Summary of Updates: 2021 FDOT Design Manual

FDM 100 (Introduction)

Figure 132.2.1 District Revisions

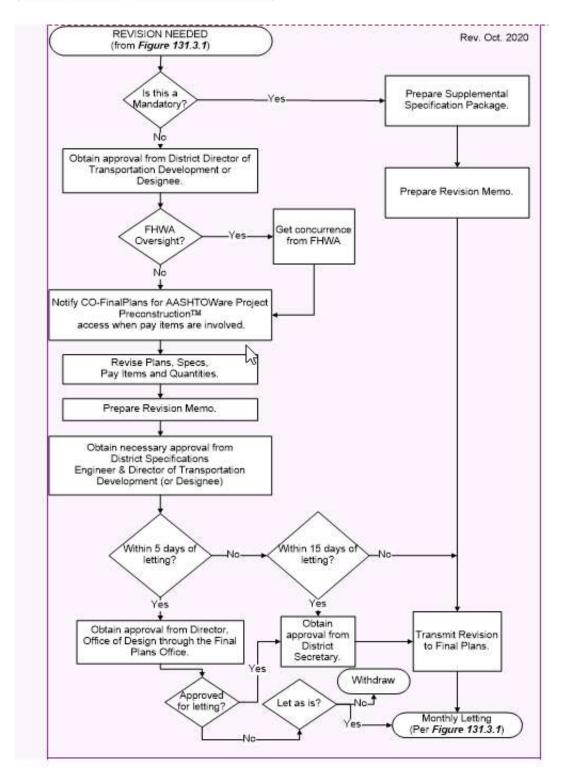
Commentary on Update: Updated Figure 132.2.1

212.13.1210.3.2.1 Channelization Islands

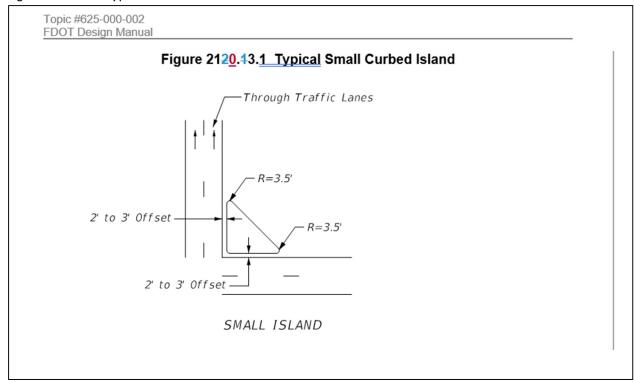
- (1) The preferred Ssize of Curbed islands should have an area of beis 100 square feet or morelarger, however, must not be less than:
 - (a) 50 square feet or larger within Ffor curbed intersections within C4, C5, or C6 Context Classification, the size should not be less than 50 square feet.
 - (b) 75 square feet or larger fFfor flush shoulder intersections within C1, C2, C2T or C3 Context Classification, the size should not be less than 75 square feet.
 - (c) 100 square feet or larger for all other locations.
- (2) Triangular islands should be at least 15 feet on a side, but not less than 12 feet, after rounding of corners.
- (3) Side dimensions of curbed islands should not exceed 100 feet on high speed roadwaysfacilities (e.g., high speed curbed roadway)., p. 722

The approach and departure noses are rounded with radii of at least 3.5 feet. *Figure* 2102.43.1 illustrates a small island with a parallel offset. *Figure* 2102.43.2 illustrates a large island with a taper offset.

Figure 210.3.6 Hardened Centerline with Traffic Separator

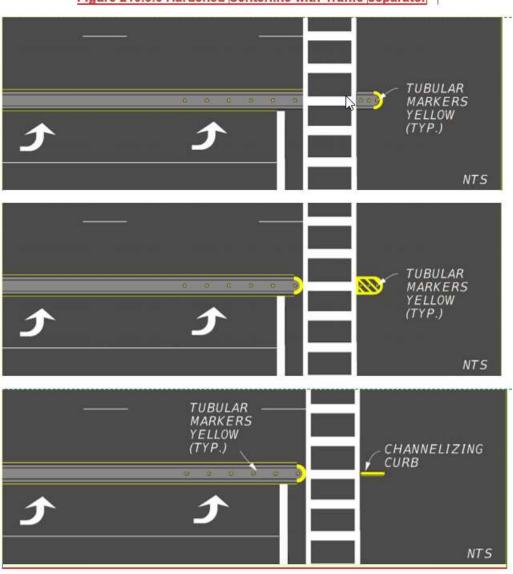
• Figure 210.3.6 - Hardened Centerline with Traffic Separator

Figure 210.3.7 Hardened Centerline without Traffic Separator

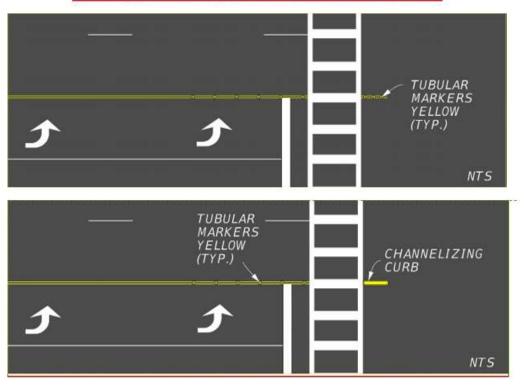
• Figure 210.3.7 - Hardened Centerline without Traffic Separator

Figure-212.12.2-Channelized-Right-Turn-Lanes¶

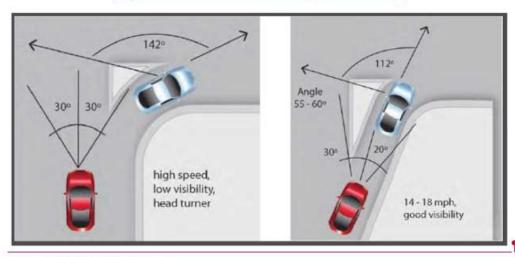
Channelized right turn lanes can be designed with a flat or near perpendicular angle of entry to the cross street (see *Figure-212.12.2*). The flat angle of entry is most appropriate for higher speed turning movements with no pedestrian accommodations. Large turning radii and angles of entry into the cross street allow higher turning speeds, reduced traffic delays, and the turning movement of large trucks. The higher speeds, angle of entry and large radii adversely impacts pedestrian safety at the crosswalk. ¶

The near-perpendicular angle of entry is preferred where pedestrian facilities are provided. Tight turning radii and angles of entry into the cross street accommodate the following:

Figure 230.3.1 – Pavement Marking Material Selection

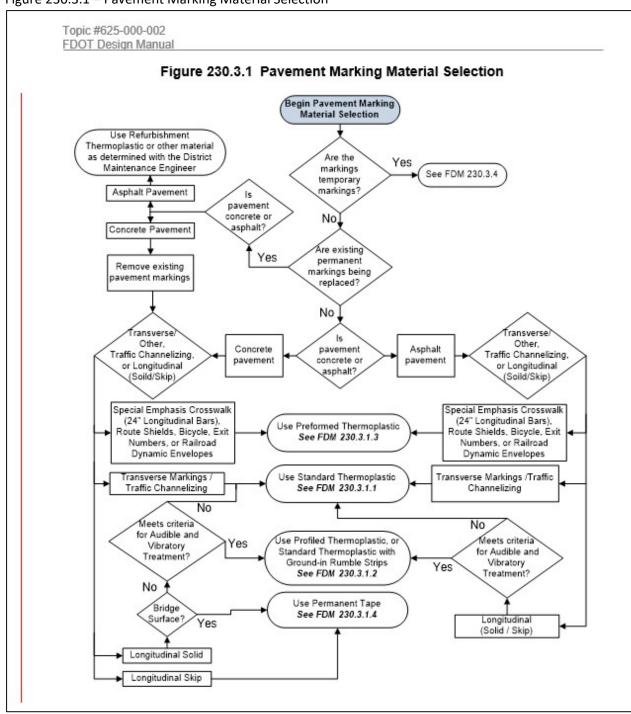
Commentary on Update: Updated flow chart to direct designers to FDM 230.3.4 for Temporary Markings

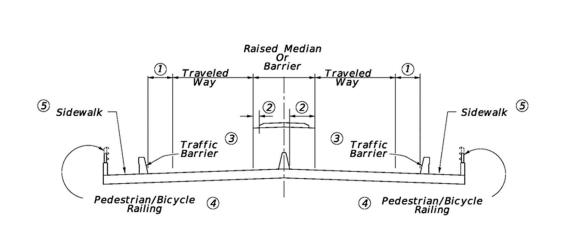
- Commentary on Update: Updated Figure 260.1.4- Revised bike lane width from 7' to 8.4'
- Date of presentation:
